CITY OF ALBUQUERQUE

RE: **Lot 19 Block 8 Volcano Cliffs Unit 5 SAD 227**
6823 Urraca NW
Grading and Drainage Plan
Engineers Stamp Date: 9/6/2021 (D10D024)
CO Certification Date: 2/15/2023

Based upon the information provided in your submittal received 3/23/2023, this plan for Certificate of Occupancy cannot be approved until the following comment are addressed.

ENGINEER'S SEAL  9/6/21 DAVID SOULE P.E. #14522	6823 RIMROCK GRADING AND DRAINAGE PLAN  Rio Grande Engineering 1606 CENTRAL AVENUE SE SUITE 201 ALBUQUERQUE, NM 87106 (505) 872-0999	DRAWN BY WCVJ DATE 9-02-21 210210083-LAYOUT-B-02-21 SHEET # JOB # 21021083
--	---	--

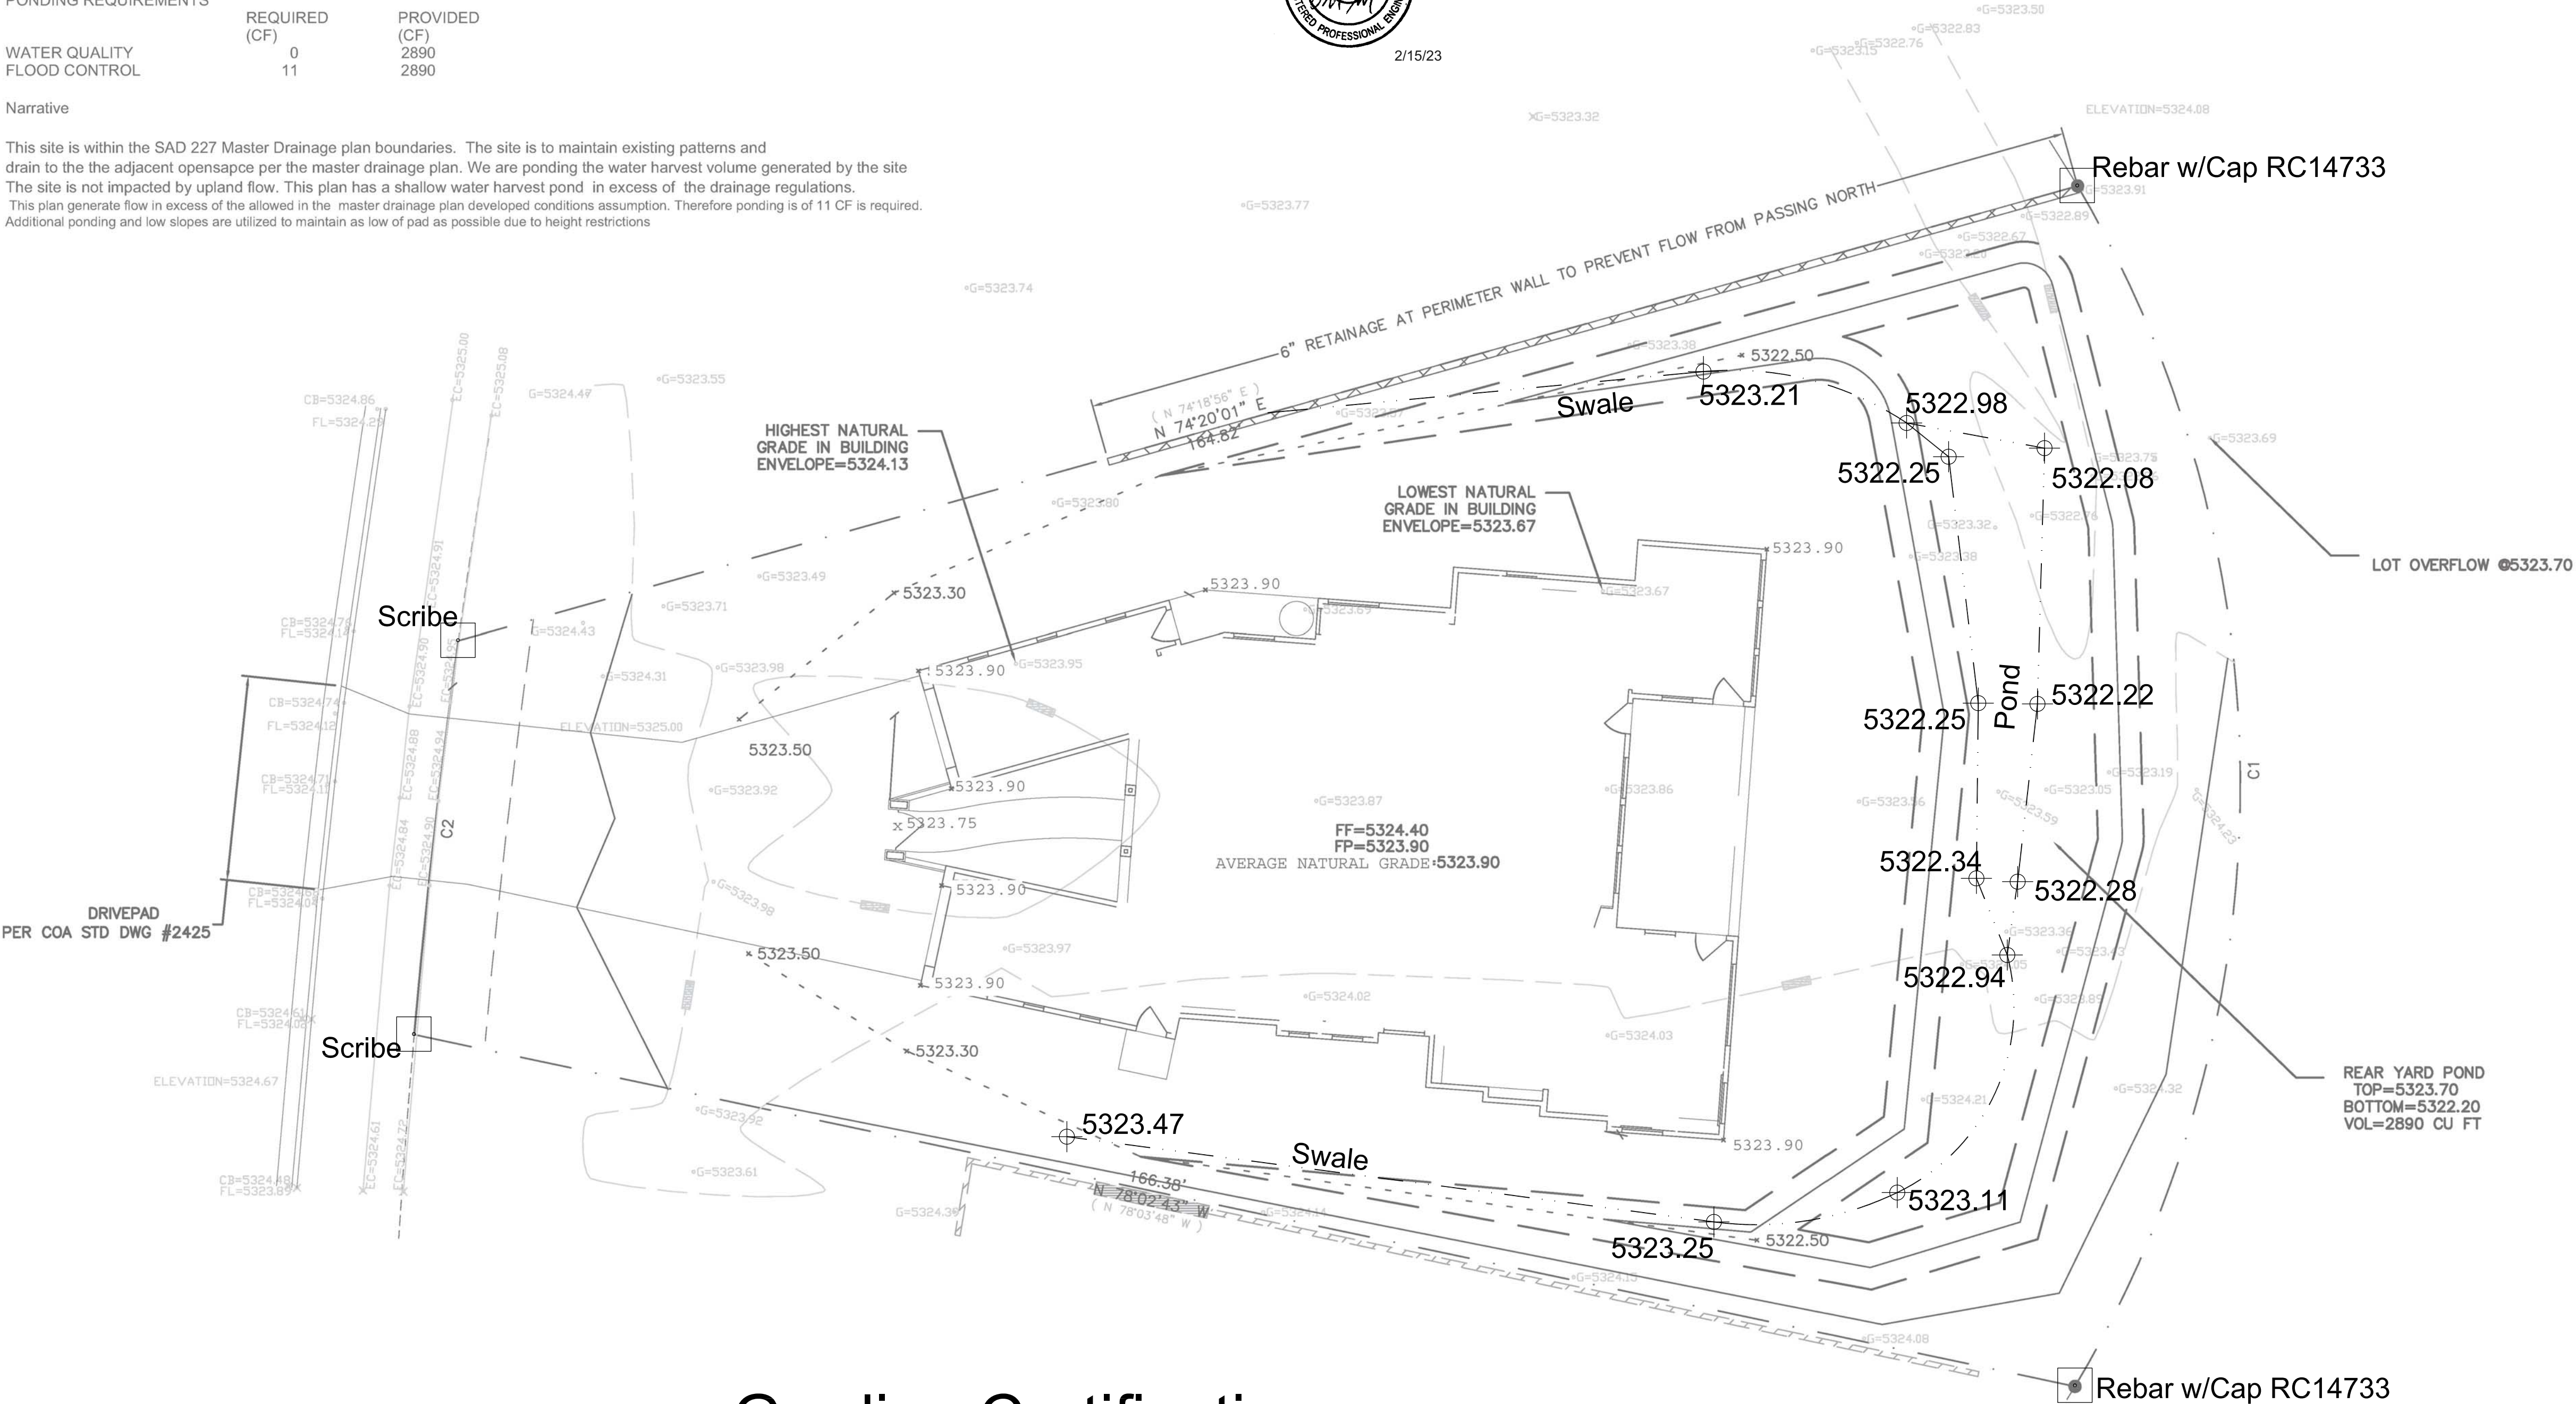
- Ponds must be filled with some type of gravel.
